## 9.4.2

### Tandem Wiring

**CHANGE TYPE:** Deletion

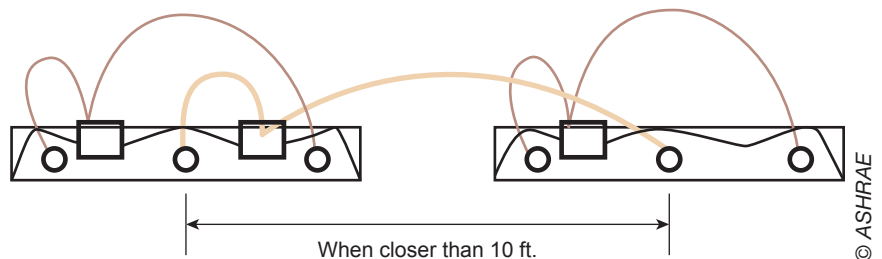
**CHANGE SUMMARY** This change removes the requirement for tandem wiring of lighting fixtures.

**CHANGE SIGNIFICANCE:** Improvements in ballast design and cost for single- and multiple-lamp ballasts have made this requirement obsolete. The requirement was intended to eliminate the use of two lamp ballasts with a single lamp.
